Item 3.**Development Application: 52-58 William Street Woolloomooloo - D/2022/1354****File No.: D/2022/1354****Summary**

Date of Submission:	4 January 2023
Applicant:	Sam McGough - Urbis
Architect/Designer:	Woods Bagot Architects
Developer:	St Mary's Cathedral College
Owner:	The Trustees of the Roman Catholic Church
Planning Consultant:	Sam McGough - Urbis
Heritage Consultant:	Alexandria Cornish - Urbis
Cost of Works:	\$19,731,219.00
Zoning:	<p>The site is located within the MU1 - Mixed Use zone.</p> <p>The proposed development is for change of use of part of the basement, lower ground, ground and first floor of the existing building for the purpose of an educational establishment and associated alterations and additions.</p> <p>The existing commercial uses and associated plant on the remaining parts of the basement, lower ground, ground and the upper floors will be retained.</p> <p>This is permissible with consent in the zone under the Sydney Local Environmental Plan 2012.</p>
Proposal Summary:	<p>The application seeks development consent for change of use of the basement, lower ground floor, ground floor and level 1 of the existing building to an educational establishment. The p

Figure 24: Extract from Noise Impact Assessment report showing the noise monitoring locations.

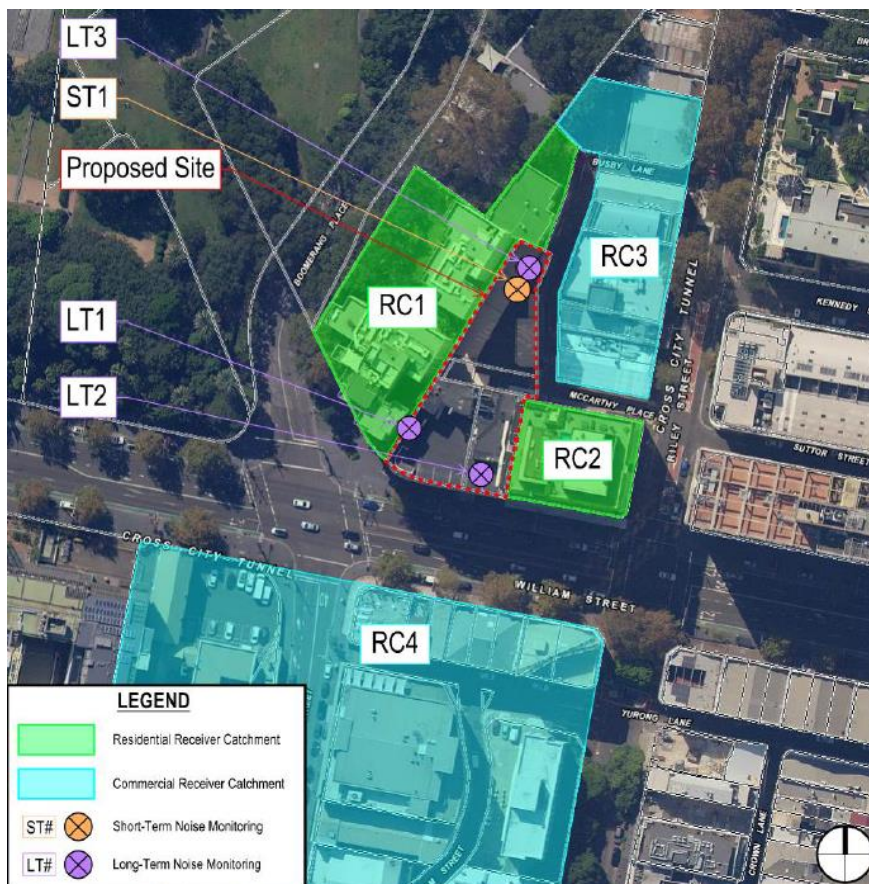
56. The submitted amended Noise Impact Assessment report noted the above assumptions and outlined the following:
- (a) There is no specific state or local noise criteria guidelines for schools/ educational establishments. As such the report adopted the noise emission level from the AAAC childcare guideline. This states the contributed LAeq, 15 minute noise level emitted from the outdoor area shall not exceed the background noise level by more than 10 dB(A) at the assessment location for residential receivers. To correct how the AAAC Childcare Centres guideline would be applied relevant to the development, the noise emissions from children are adjusted to Year 7-12 (high school students) scenarios.
 - (b) Long term and short-term noise monitoring were undertaken at the points shown on Figure 24 below:

- (c) The measured rating background noise (RBL) at the residential receivers surrounding the site is 55dB(A) and as such the assumed noise emission limit is 65dB(A).
- (d) Noise monitoring at the existing St Mary's Cathedral College on 30 May 2023 was undertaken during a school outdoor break period which is considered representative of the typical noise level for the proposed space. The measurements were adjusted to reflect the differences between the modelled environment and the subject site as follows:

- (i) Consideration of canyon effects in the area due to hard surfaces surrounding the terrace, including reflections from adjoining buildings. Three dimensional acoustic modelling for noise emissions from the outdoor area were conducted using the software SoundPLAN (Version 9.0).

- (ii) Canopy reductions.
 - (iii) Consideration of additional noise from the sunken basketball court (at the modelled environment).
 - (iv) The modelling did not include proposed landscaping in order to provide a worst-case scenario.

- (e) Based on the above, the submitted Noise Impact Assessment report concluded the following:
- (i) The most noise affected location will be on the immediate western boundary, within the central portion of the outdoor open space area (refer to Figure 25). This broadly aligns with the eastern facade of the Park Lane Towers building, a residential receiver. Based upon the three dimensional acoustic modelling, the worst-case noise emission level at this receiver is 62dB(A) which complies with the adopted noise emission limit of 65dB(A).

- (iii) As the noise travels upwards, the noise emission levels decrease to approximately 56dB(A) at upper levels which is compliant with the noise emission limit.

- (iv) At the residential receiver to the east, the Paramount Complex (apartments), the noise emission level is 56dB(A), compliant with the noise emission limit.

Figure 27: Site plan showing approximate separation distance between the raised terrace and the balconies at 60-70 William Street (Paramount Apartments).

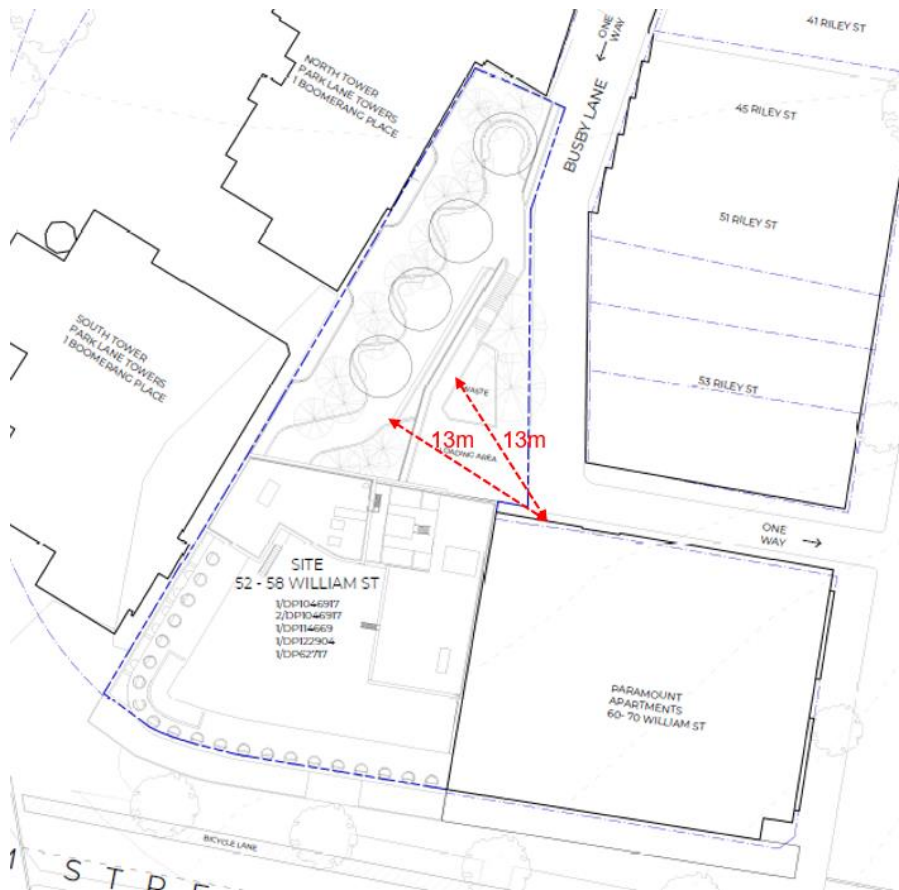
63. The nearest residential properties which are likely to be impacted by the proposal from a visual privacy perspective are the rear facing residents at 60 - 70 William Street (Paramount Apartments) and the residents with windows and balconies facing the proposal at 1 Boomerang Place (Park Lane Towers).
64. Due to the proposed setback of the terrace from the eastern boundary at the southern edge, there is a separation distance of approximately 13 metres from the nearest potential viewpoint to the balconies at 60-70 William Street (see Figure 27). There is also an approximate 13 metre separation distance from the proposed external staircase and the balconies at 60-70 William Street.

65. Although the requirements of the Apartment Design Guidelines (ADG) do not apply to educational establishments, they can be used as a guide to determine appropriate separation distances to maintain visual privacy between buildings in built up environments. The ADG recommends a minimum separation distance of 12 metres between habitable rooms/balconies up to 12 metres and 4 storeys in height.

Figure 30: Extract of section showing view impacts of increasing the fence height by 0.45 metres.

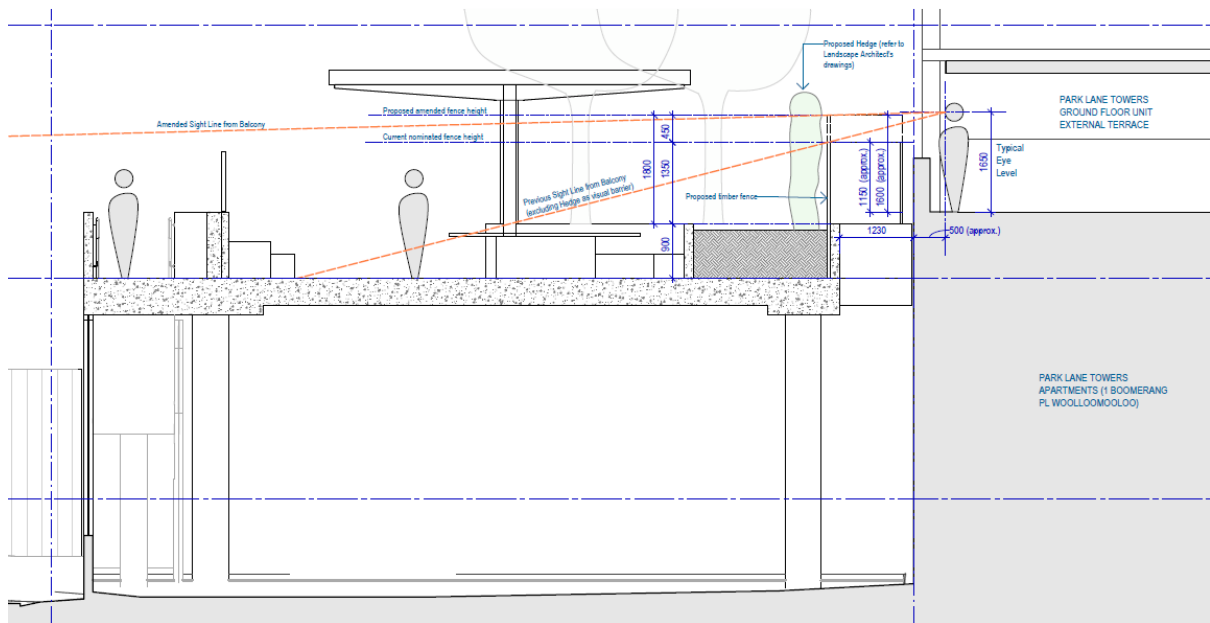
68. Notwithstanding, concerns remain that the proposed terrace will have privacy impacts on the lowest eastern facing window (Figure 28) and the eastern facing ground level private balcony (Figure 29) of the adjoining apartments at 1 Boomerang Place.

69. Further discussions with the applicant and amended view analysis demonstrates that increasing the height of the proposed fence along this boundary by 0.45 metres to 1.8 metres in height is the minimum increase necessary to mitigate privacy concerns, while balancing the competing objectives of maintaining views, daylight access and ventilation to the ground floor apartment (see Figures 30 and 31).

70. A design modification condition has therefore been included within the recommended conditions of consent to ensure that the fence height is increased to mitigate privacy impacts.
71. The conditioned proposal is considered to provide appropriate visual privacy for residents within 1 Boomerang Place, considering the built-up nature of the context and the fact that this window and balcony currently borrow amenity across the subject site boundary.

Figure 32: Extract from applicant report showing pedestrian route from the main campus to the proposed campus.

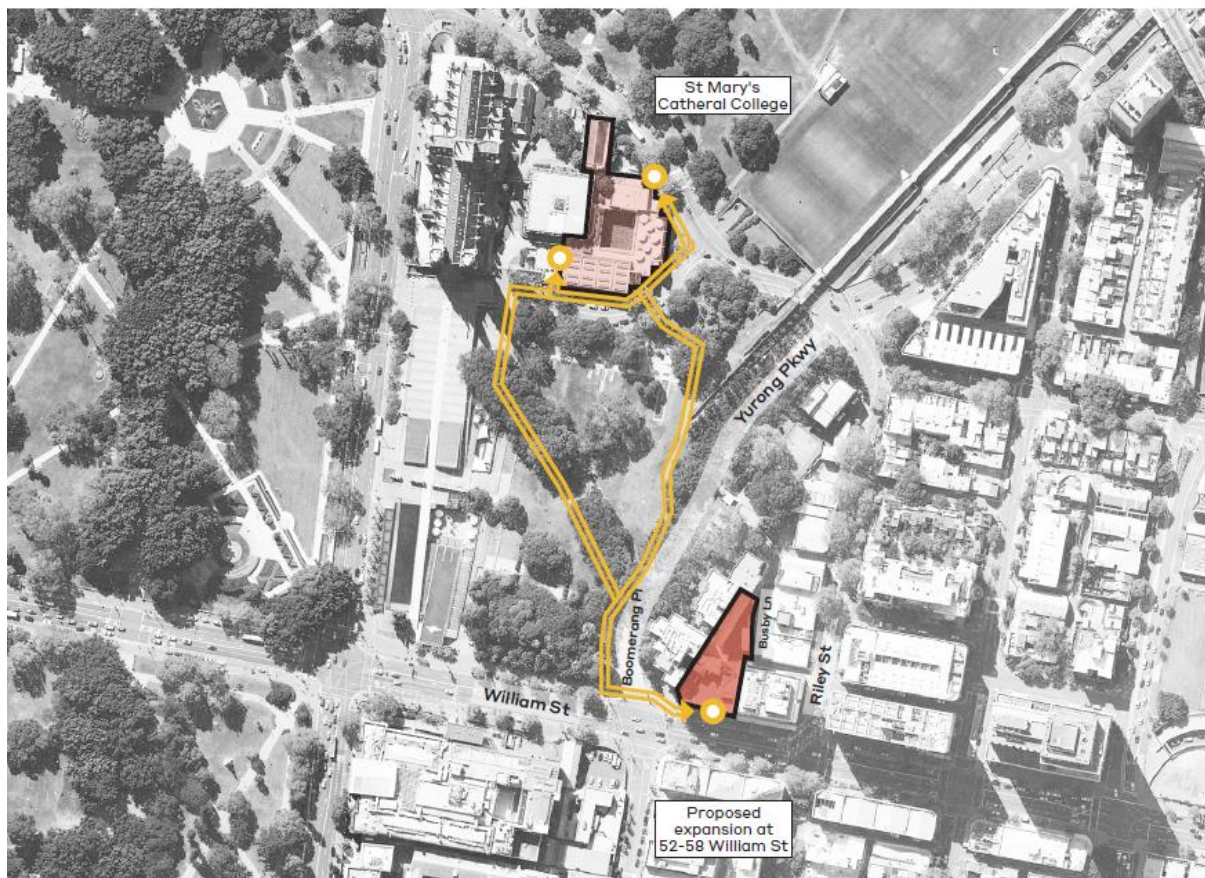
- Students to travel to and sign in at the primary campus in the morning. Students will then walk to the proposed new campus (see Figure 32).
 - Students will largely travel to the primary campus via public transport (92 per cent travel via bus, ferry or train) or walking (3 per cent walk) as reflected in the student survey of 597 students undertaken in 2022.

- Students travelling to the primary campus via bicycle will store their bicycle within the existing facilities on the primary campus during the day.

73. Transport for NSW and Council's Traffic team reviewed the amended application and advised that it was acceptable from a traffic management perspective subject to conditions. These conditions have been included within the recommended conditions of consent in Attachment A.

Figure 33: Extract of shadow diagrams showing proposed shadows between 9am and 3pm on June 21.

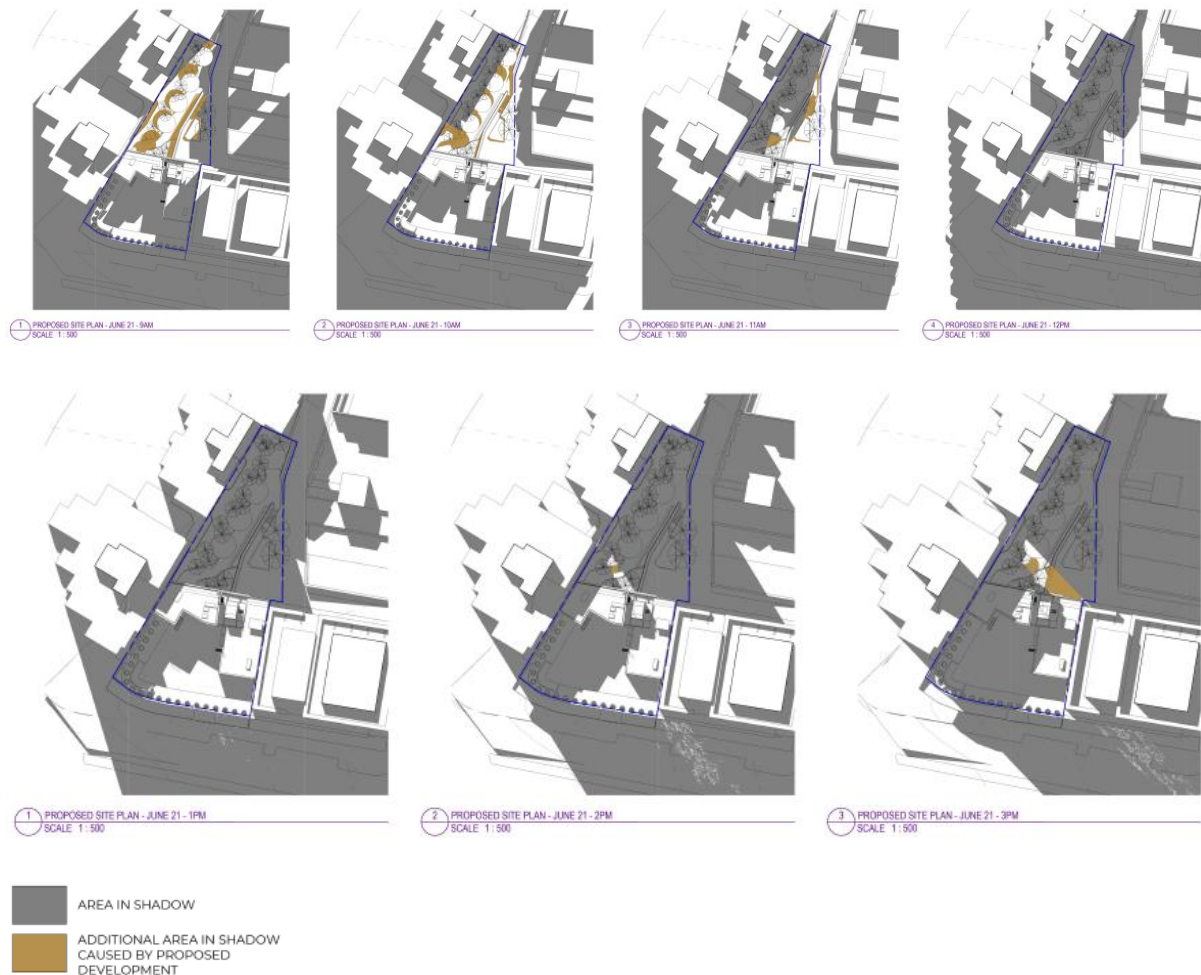
74. Shadow diagrams were submitted with the amended plans for the raised outdoor terrace area. These diagrams demonstrate the impact of the proposed new structure and shade structures on adjoining properties between 9am and 3pm on June 21 (see Figure 33 below).

75. The diagrams show that due to the position of the site, all new shadows cast from the proposed new structures, between 9am and 3pm on June 21, will fall within the subject site. The proposal will not have a shadow impact on the open space areas and living room windows of adjoining properties. The proposal is therefore considered acceptable from a solar access perspective.
